## ADDENDUM NO. 03

PROJECT: South Orangetown Central School District  
PHASE 1: 2022 BOND

CPL PROJECT NO. 14457.20

DATE: November 9, 2023

Issued	Scale
10/18/23	As indicated
Project Status	Checked By
BID DOCUMENTS	LT
Drawn By	LT
Drawing Title	
NEW WORK PLAN - AREA A&B	
Drawing Number	
WOS A200

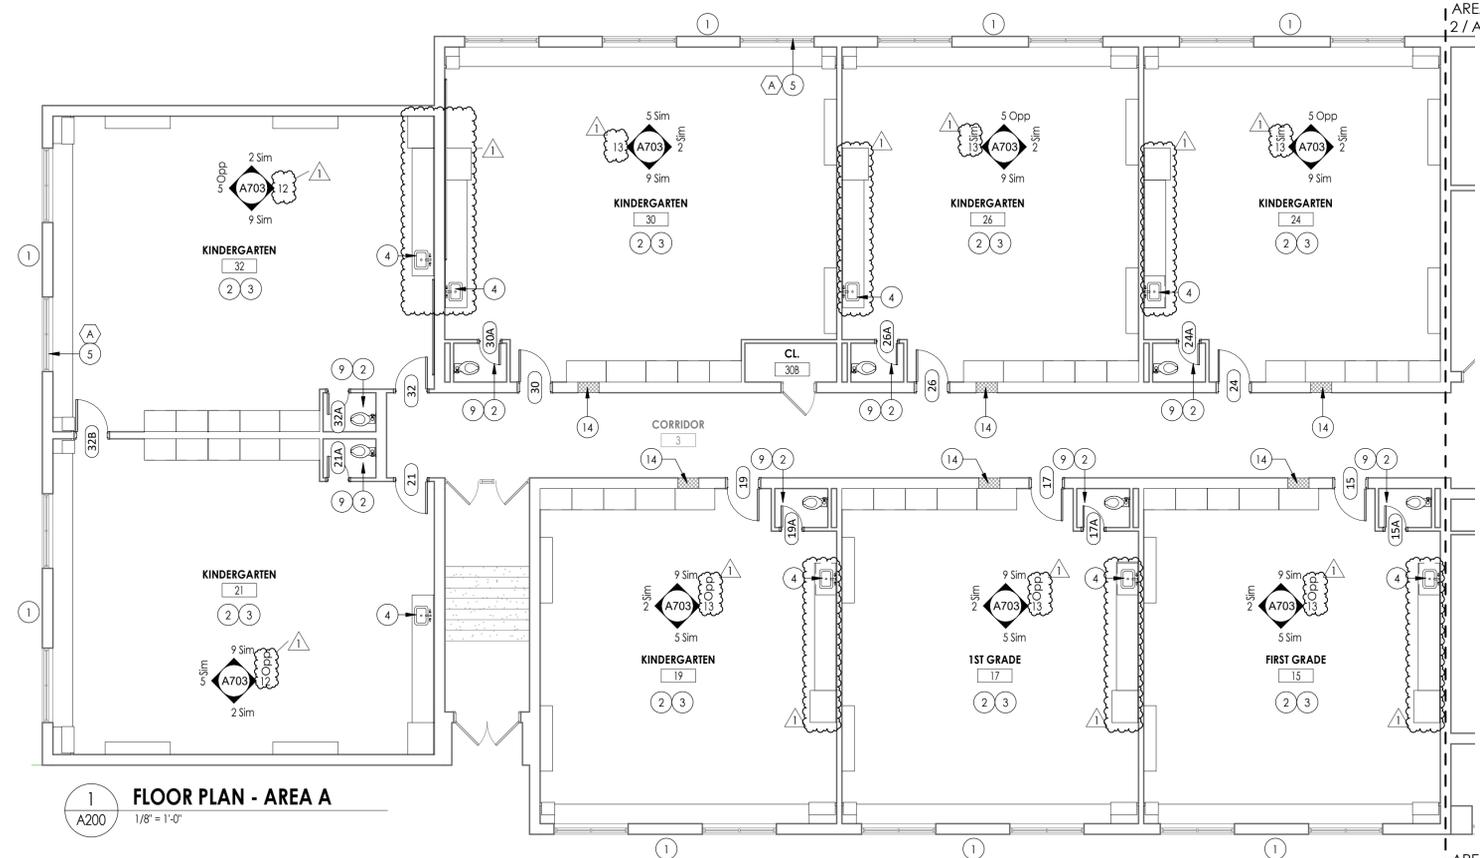
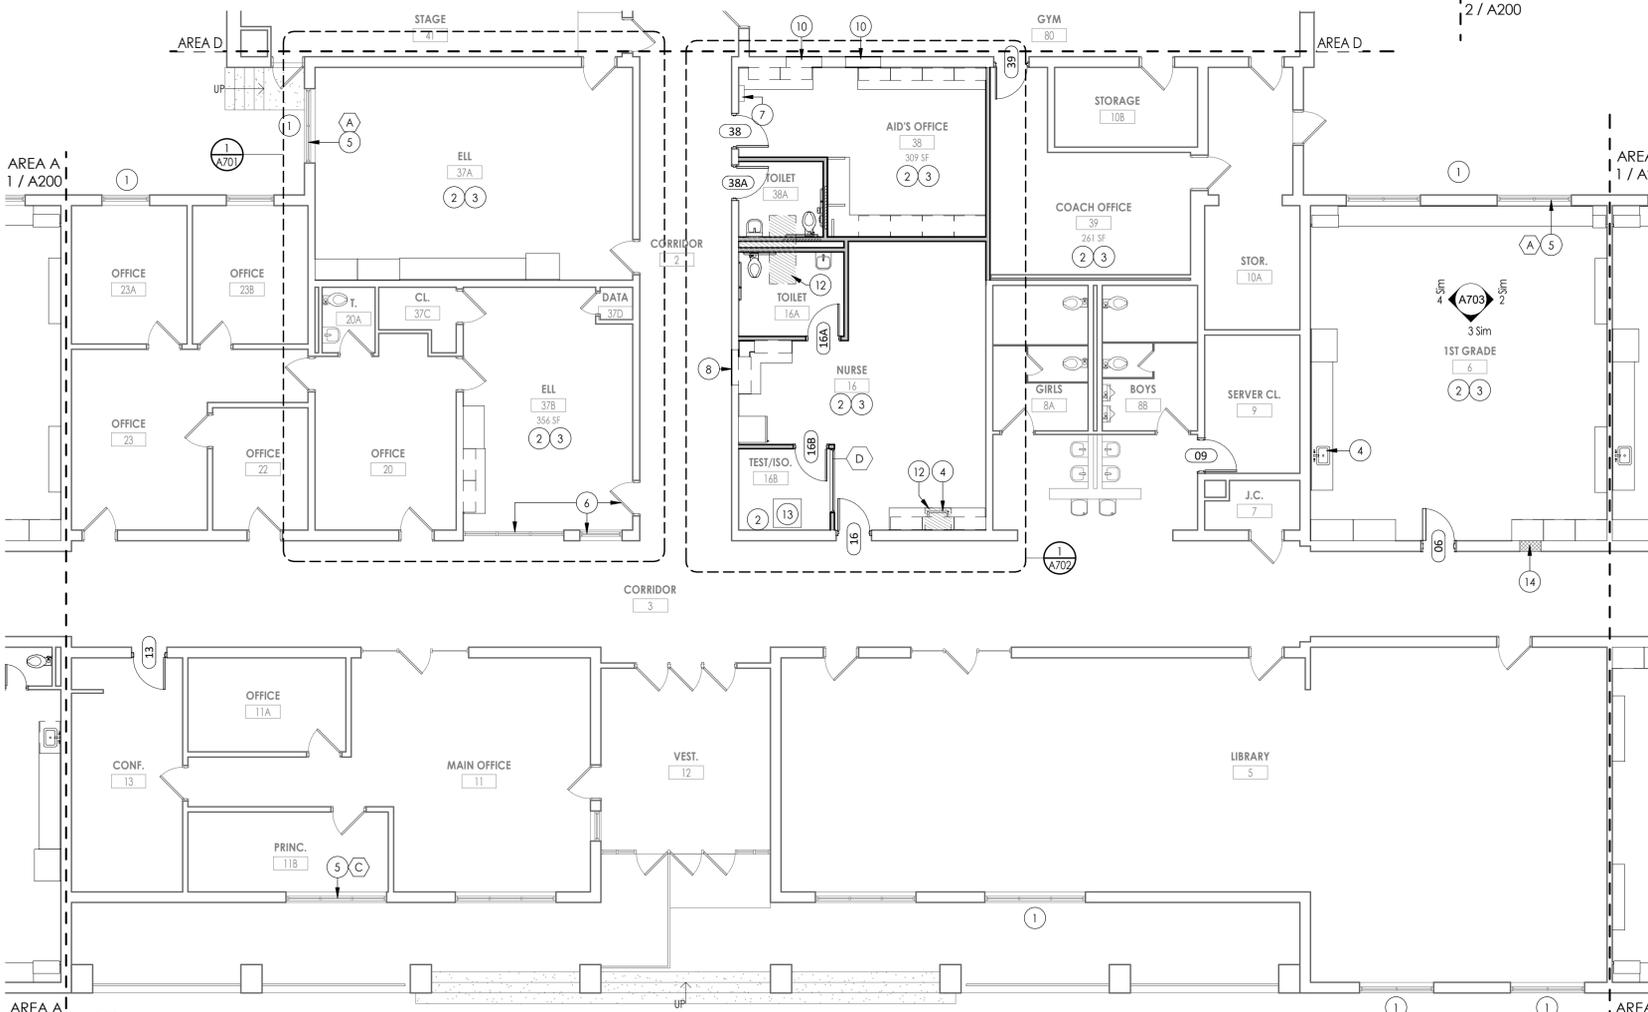
- 4.1 Drawing GEN S801; Detail Section 2: Replace pier footing reference 'A513' with 'S804'
- 4.2 Drawing WOS A200: Replace with attached revised WOS A200

Drawing Title NEW WORK PLAN - AREA C

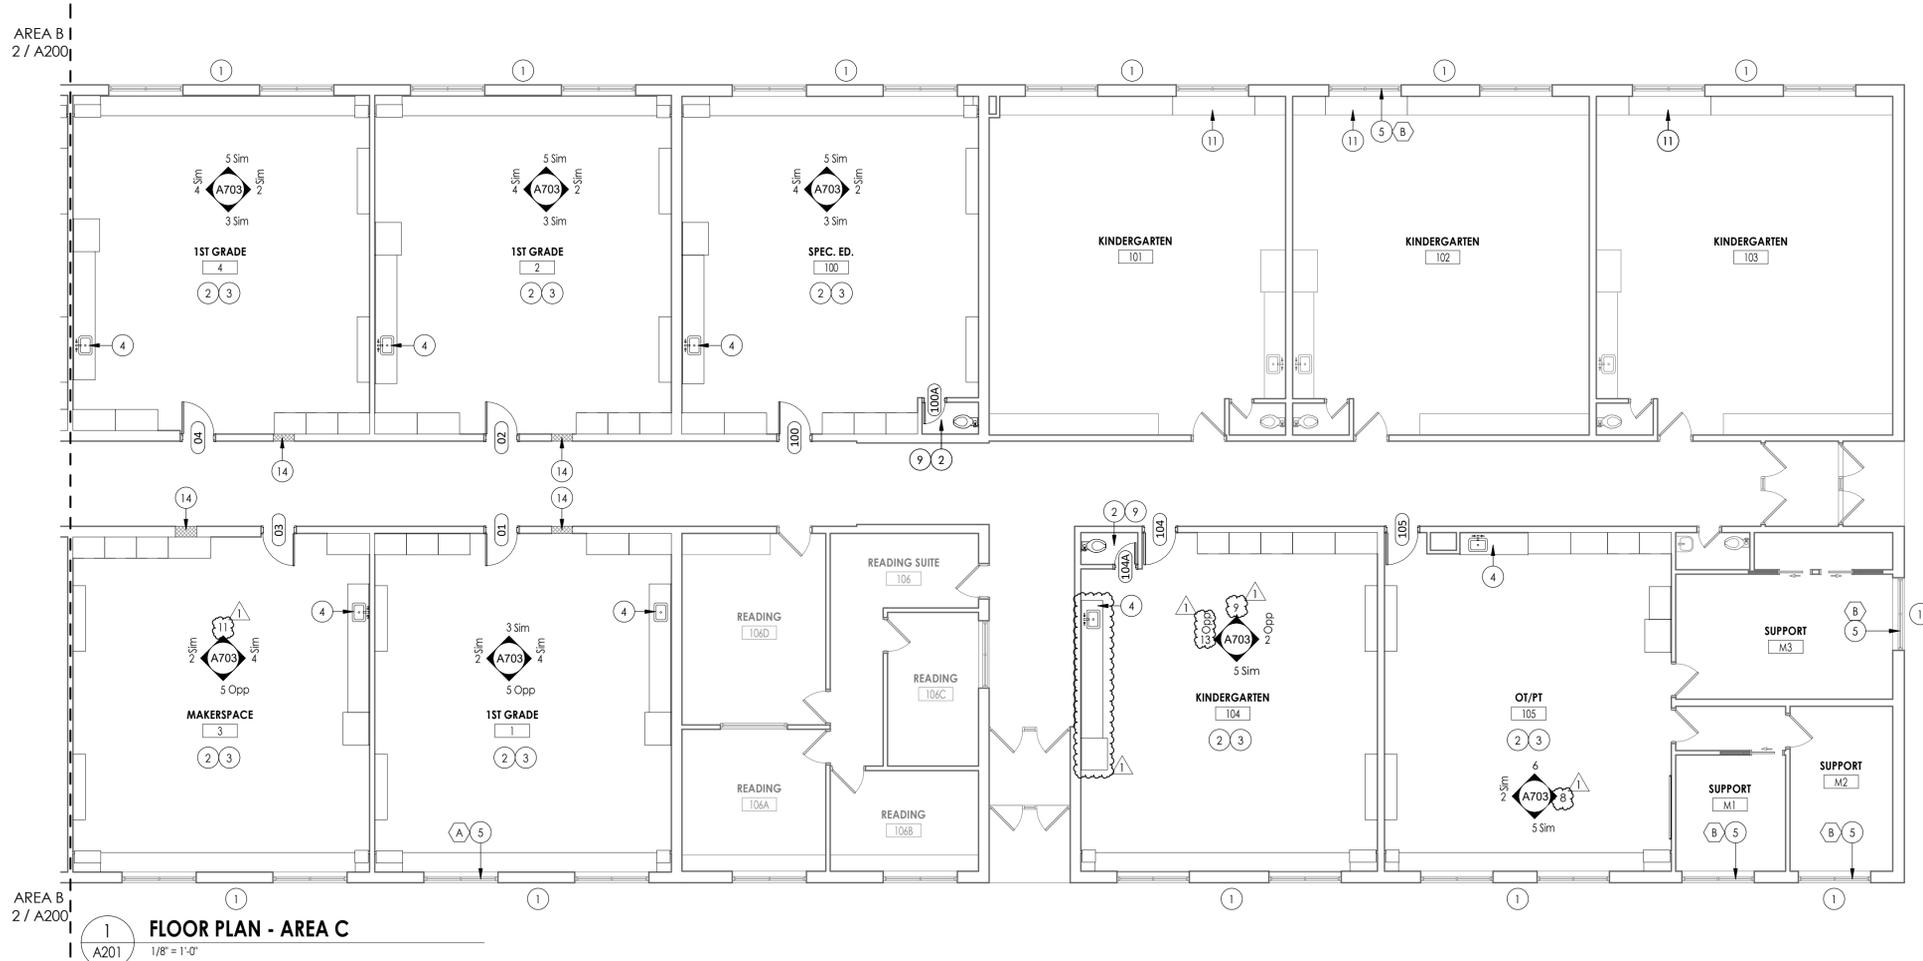
- 4.3 Drawing WOS A201: Replace with attached revised WOS A201
- 4.4 Drawing WOS A202: Revise Keynote 11 to read as follows:  
11. ALTERNATE 1/ GC-01: INFILL DEMOLISHED UV LOCATION WITH NEW CASEWORK AS SCHEDULED. REFER TO A800 FOR DETAILS.

Drawing Number: WOS A702

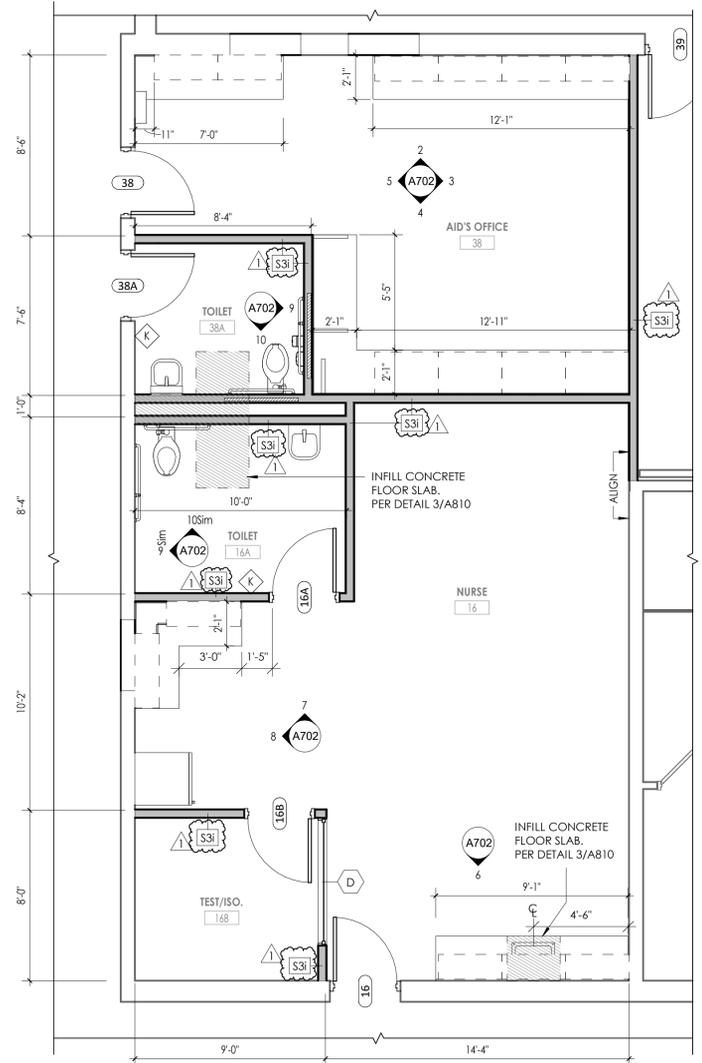
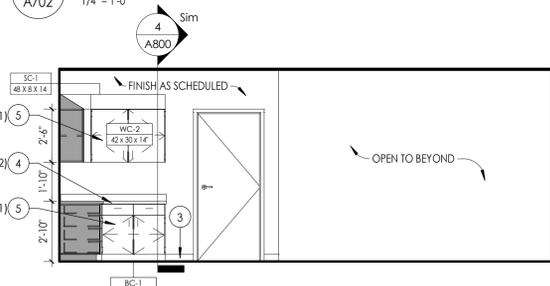
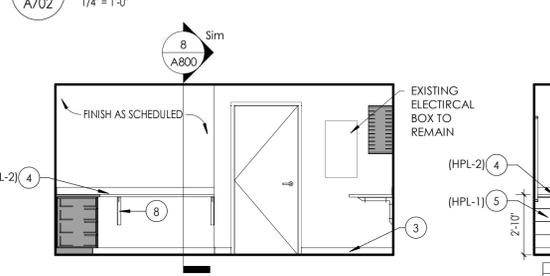
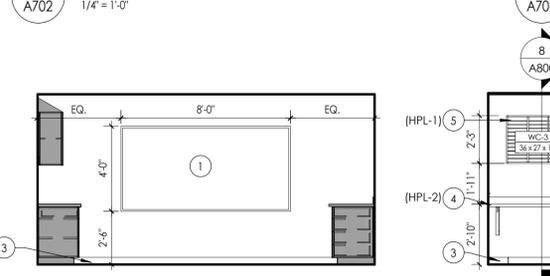
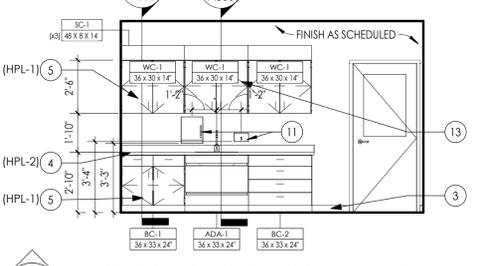
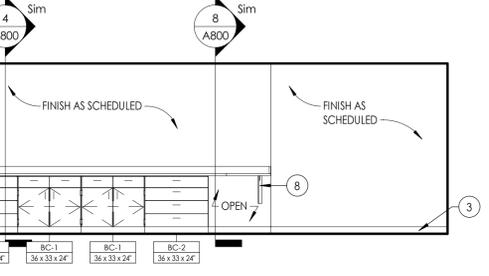
- 4.5 Drawing WOS A701: Replace with attached revised WOS A701
- 4.6 Drawing WOS A702: Replace with attached revised WOS A702
- 4.7 Drawing WOS A703: Replace with attached revised WOS A703

Drawing Number: **WOS A800**

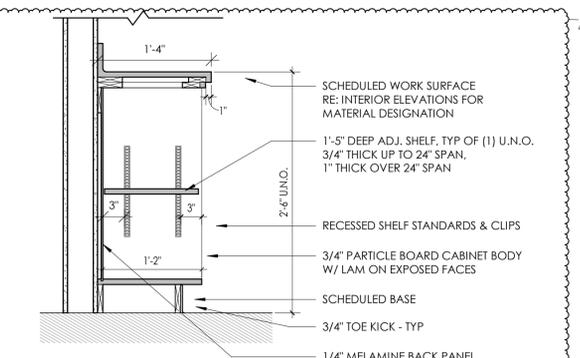
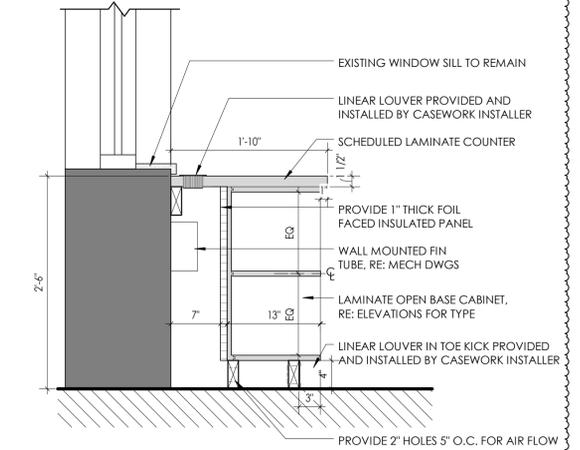
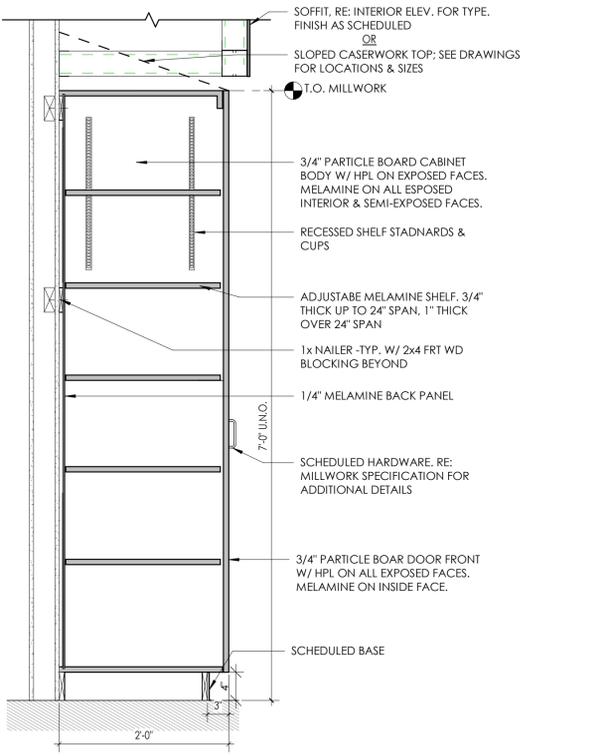
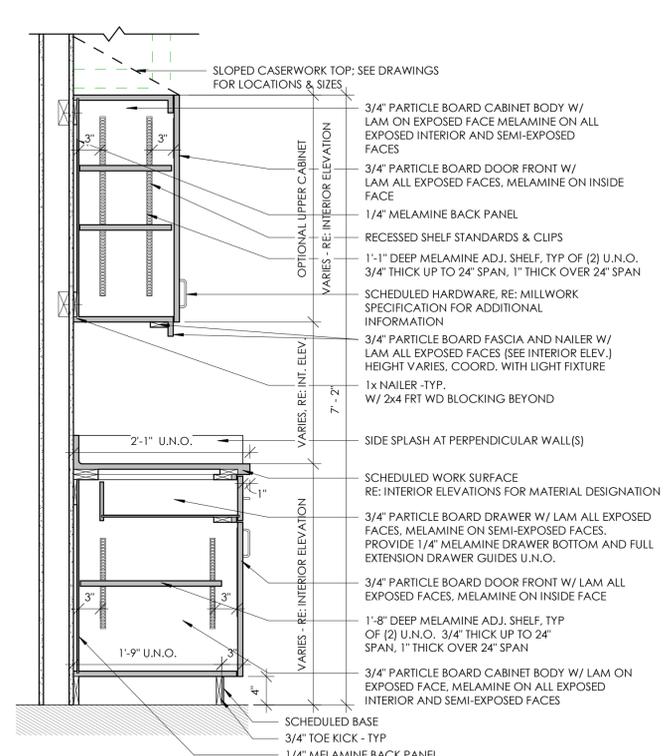
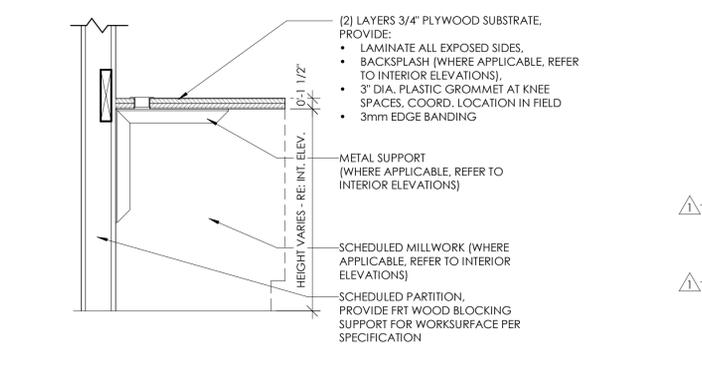
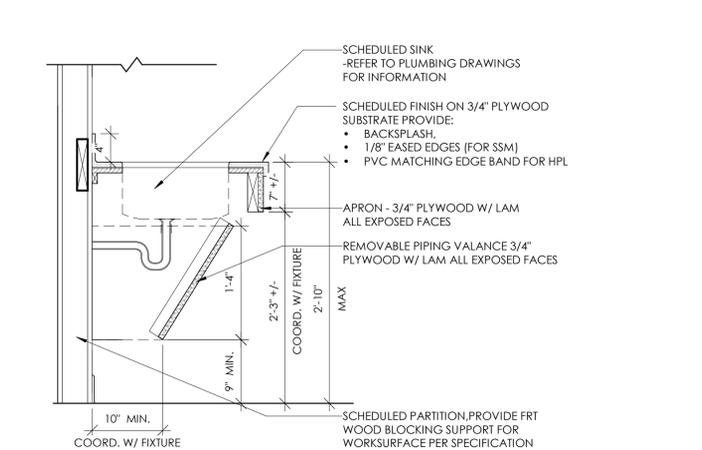
- 4.8 Drawing WOS A800: Replace with attached revised WOS A800
- 4.9 Drawing WOS A810: Replace with attached revised WOS A810
- 4.10 Drawings CLE A100 & A102: Revise Demolition Keynote C3 to read as follows:  
C3. REMOVE ACT CEILING SYSTEM IN ITS ENTIRETY. SALVAGE CEILING TILES.

**SHEET INFORMATION**  
 Issued: 10/18/23 Scale: As indicated  
 Project Status: BID DOCUMENTS  
 Drawn By: LF Checked By: LT  
 Drawing Title: REFLECTED CEILING PLAN - AREA C  
 Drawing Number: CLE A601

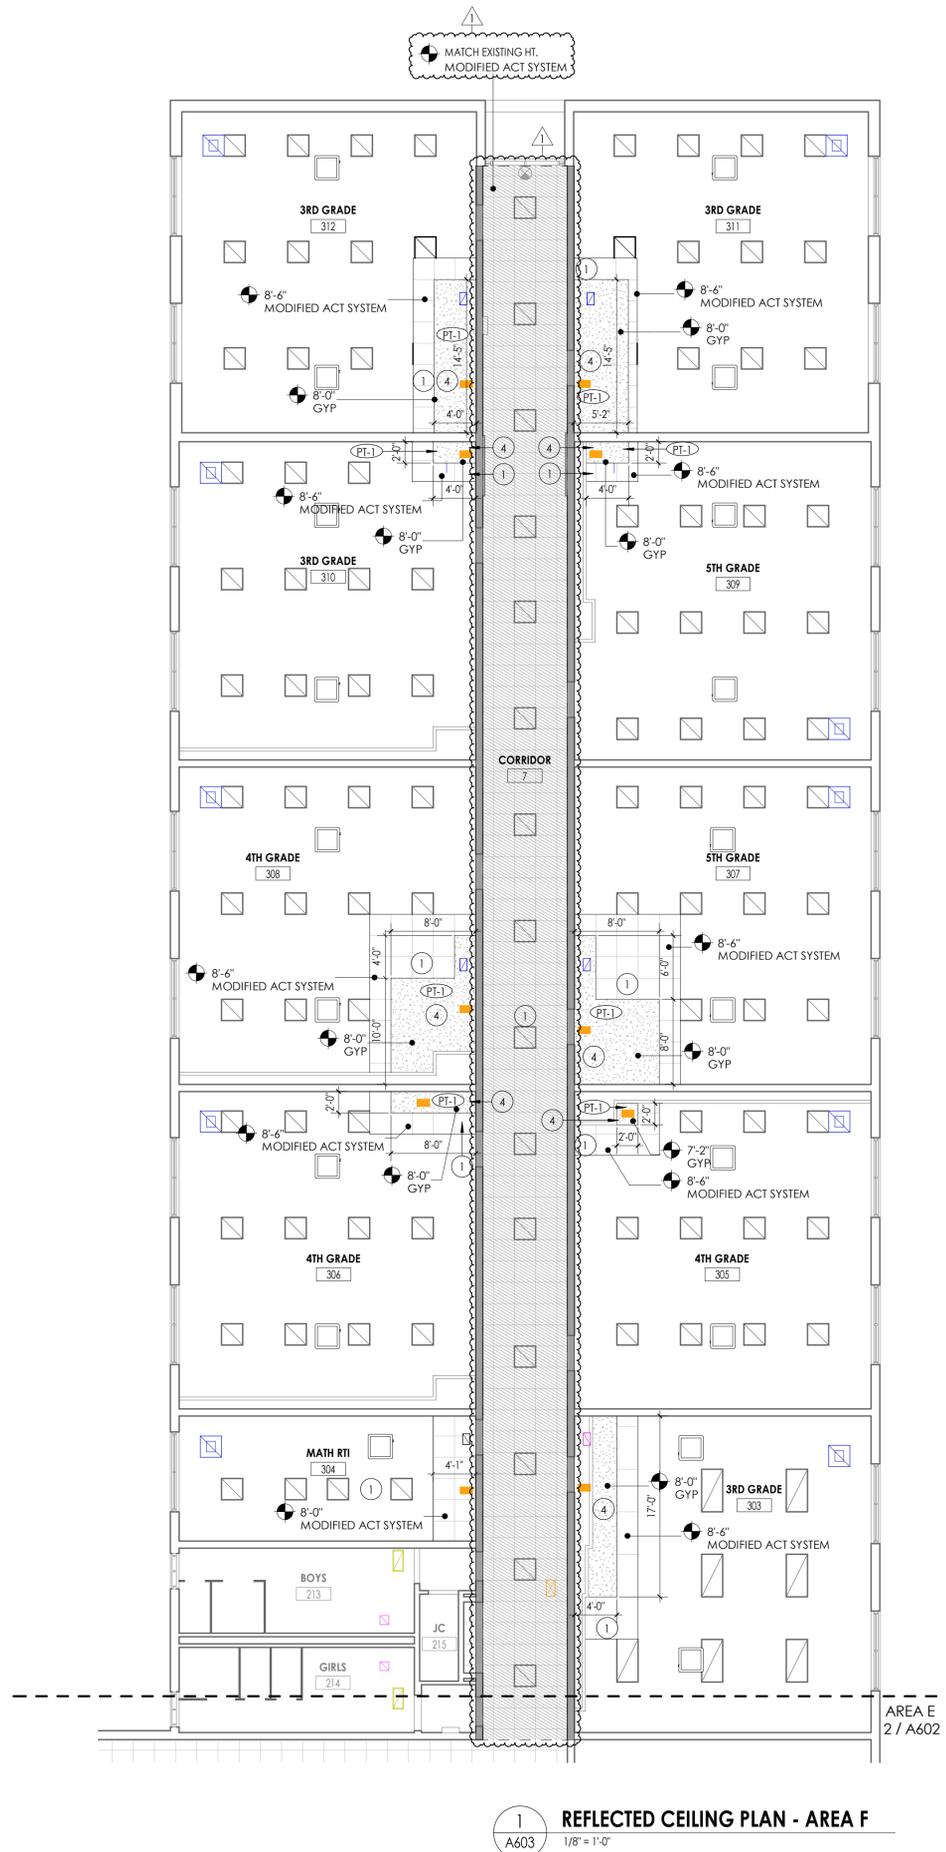
- 4.14 Drawing CLE A601: Replace with attached revised CLE A601
- 4.15 Drawing CLE A603: Replace with attached revised CLE A603
- 4.16 Drawing CLE A701: Replace with attached revised CLE A701

Drawing Number  
**CLE A810**

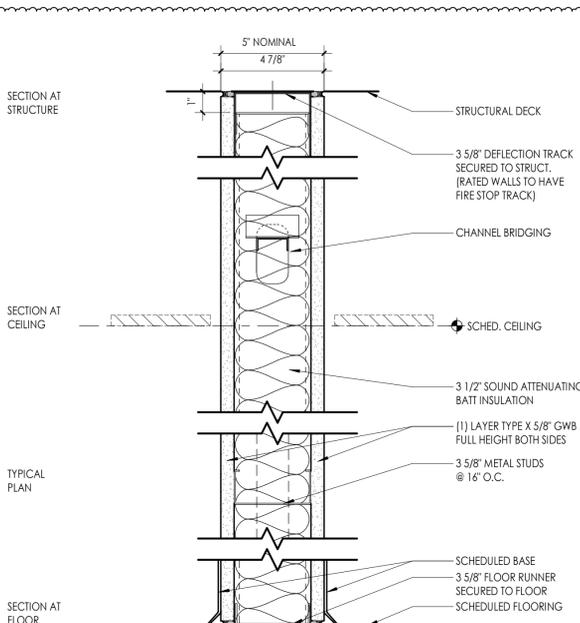
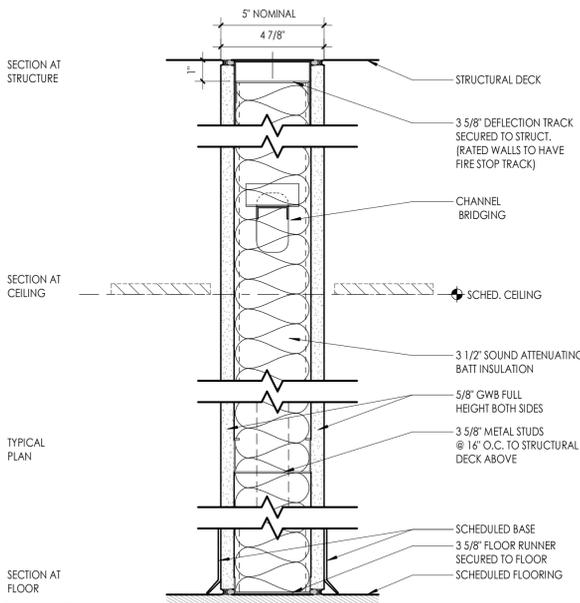
- 4.11 Drawing CLE A101: Replace with attached revised CLE A101
- 4.12 Drawing CLE A103: Replace with attached revised CLE A103
- 4.13 Drawing CLE A202:  
New partition wall between room ST. 300E & ST. 300D – Revise wall tag to be S3i.  
New partition wall between room ST. 300D & Corridor – Revise wall tag to be S3ir.

- 4.18 Drawing CLE A800: Replace with attached revised CLE A800
- 4.19 Drawing CLE A810: Replace with attached revised CLE A810
- 4.20 Drawing CLE A900:  
DOOR SCHEDULE – NEW; Door 202A: Revise Panel Type to be PNL-N-WD  
DOOR FRAME TYPES; FRM-20 HM1: Sidelite Glazing to be type G2 - Fire Rated  
DOOR PANEL TYPES; PNL-G2-WD to be Glazing type G2 – Fire Rated
